# AXC F 2152 – CHANGE NOTES

## Change notes for the AXC F 2152 controller

Application note  
108427\_en\_10

This document contains all changes made between firm-ware version 1.0.0 and the current firmware version of the AXC F 2152 controller (Order No. 2404267).

#### Left-alignable INTERBUS master

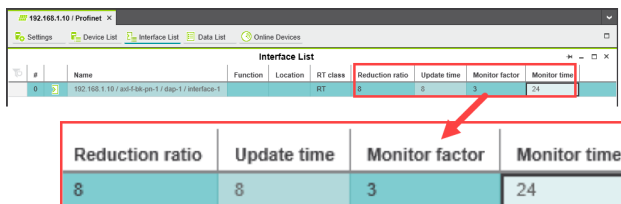
The controller now supports left-alignment of the INTERBUS AXC F XT IB master (Order No. 2403018).

Figure 2 Select Trigger task

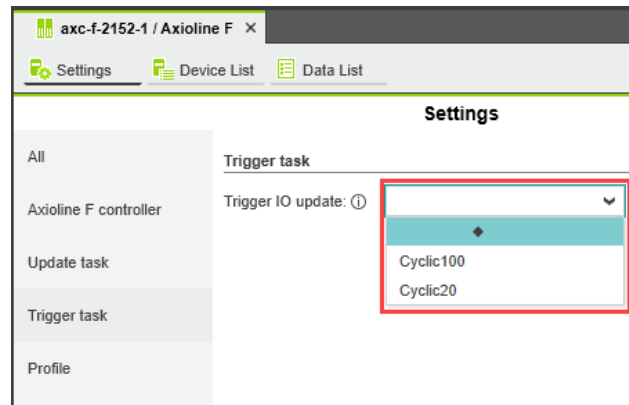
You can now specify the refresh interval for Axioline F I/O data. This is done by selecting which task triggers the Axioline F I/O data update in the PLCnext Engineer project.

- Select the “Trigger task” view in the “Settings” editor.
- In the drop-down list, select the task that is to trigger the Axioline F I/O data update.

If you do not select a task, the update will occur by default every 50 ms.
